UNITED STATES OF AMERICA
NUCLEAR REGULATORY COMMISSION

(Comanche Peak Steam Electric Station
Station, Units 1 and 2)

CASE'S ANSWER TO APPLICANTS' STATEMENT OF
MATERIAL FACTS AS TO WHICH THERE IS NO GENUINE ISSUE REGARDING
CONSIDERATION OF FRICTION FORCES IN THE DESIGN
OF PIPE SUPPORTS WITH SMALL THERMAL MOVEMENTS

AFFIDAVIT OF CASE WITNESSES JACK DOYLE AND MARK WALSH

TENSION LOAD VS. ANCHOR DISPLACEMENT
FOR A 1/2" DIAMETER KWIK-BOLT EMBEDDED
2 1/4" IN THE CONCRETE

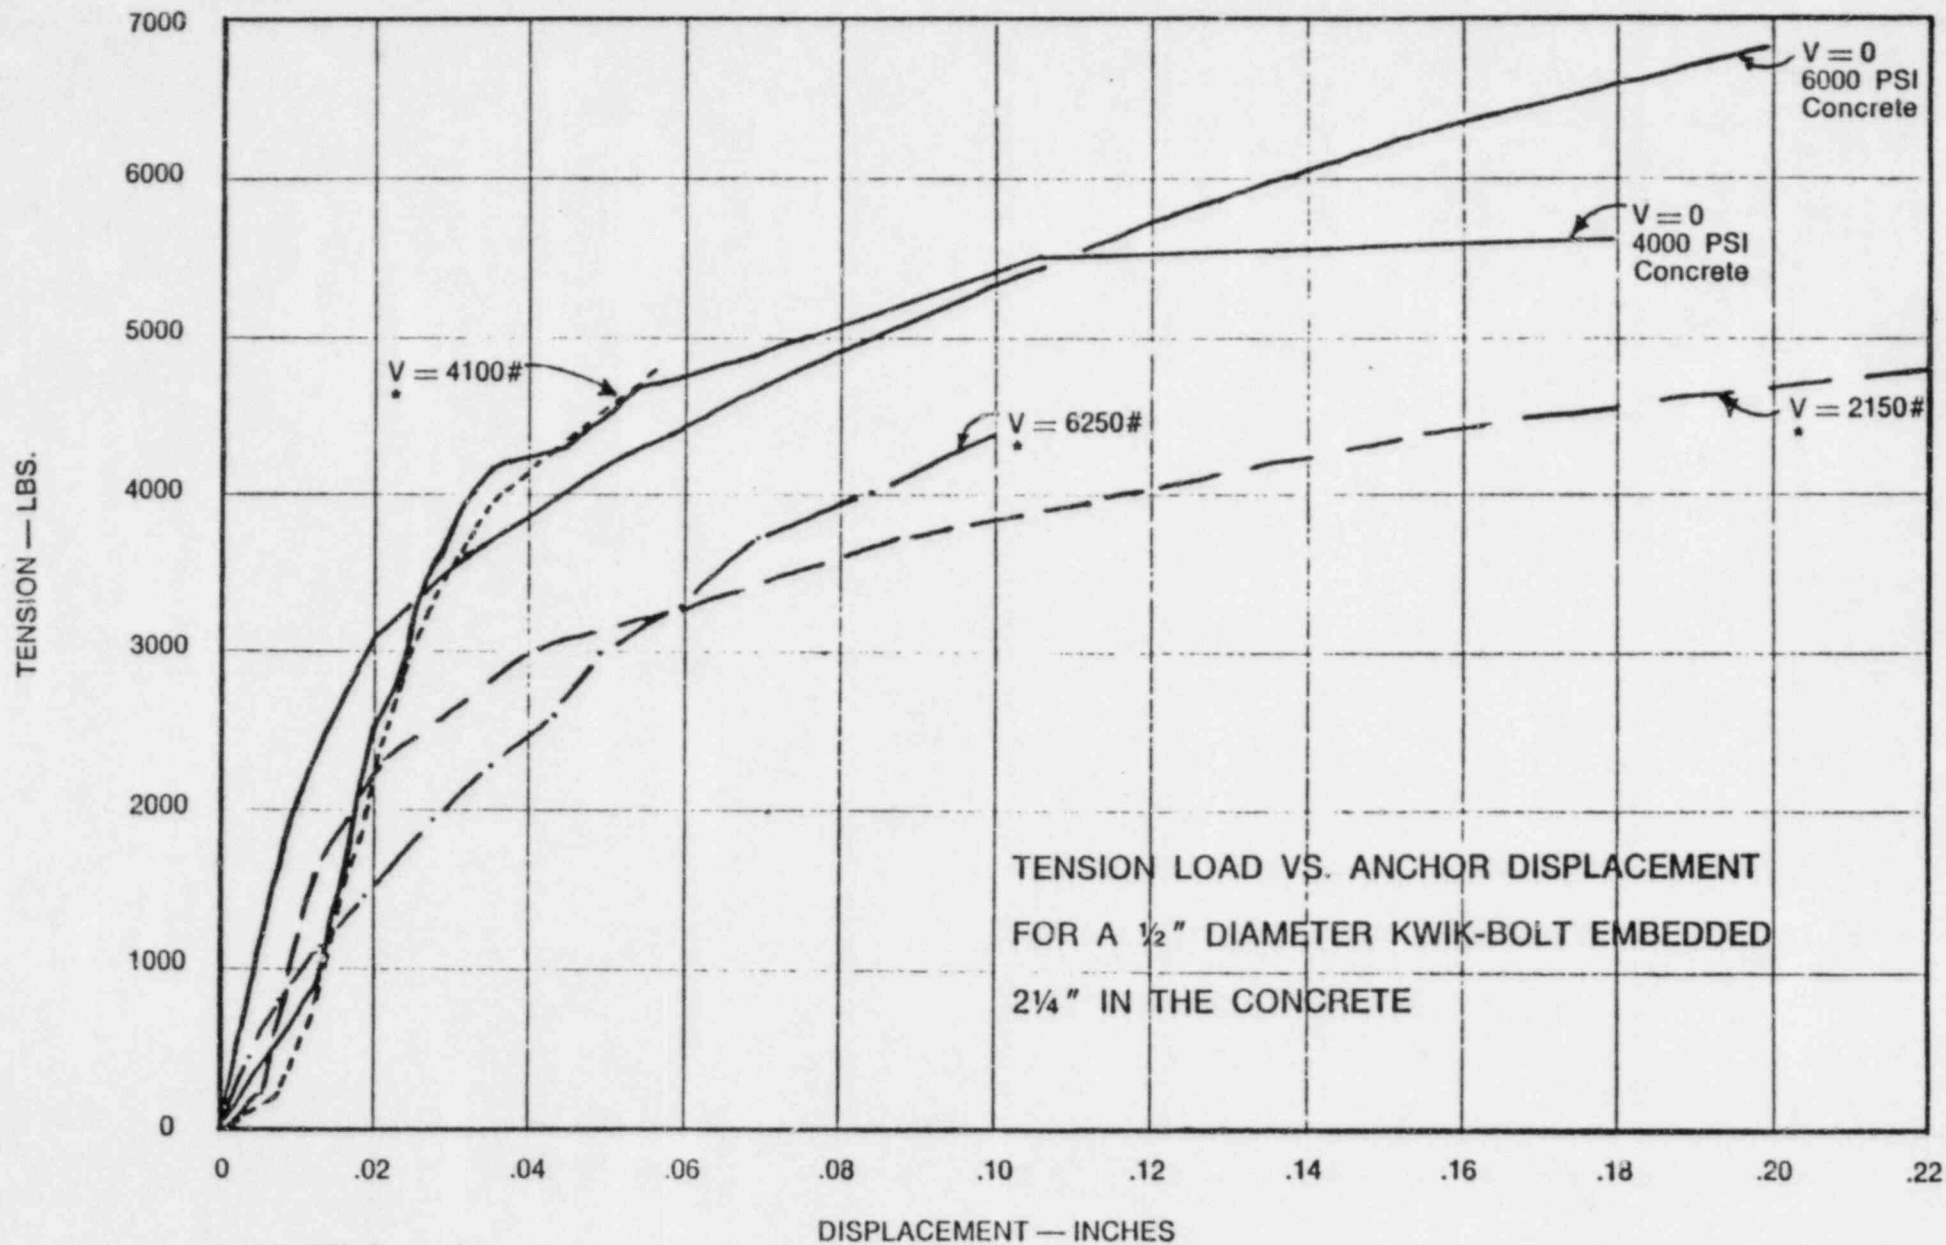
Reviewing the load displacement diagram for a 1/2" diameter Hilti bolt at 1/16" deflection, the load on the bolt (labeled A in the drawing above) would be 4,900 lbs., with the shear load equal to zero and 4,000 psi concrete (see attached 4/15/74 letter from Robert D. Dalton, Jr., President of Abbot A. Hanks Testing Laboratories, to Hilti Fastening Systems, Inc., under Subject of Combined Shear and Tension Testing: KWIK-Bolt). But the allowable is listed as 1,100 lbs. for 2-1/4" embedment, as shown in the PSE Manual (see attached page 8 of 10 of Section V, Hilti Concrete Anchor Bolts, Rev. 0, 1/8/82). Now in the event of a seismic load, this support will only have one anchor bolt (labeled B in the drawing above), since the bolt A exceeded its capacity for predictable behavior.
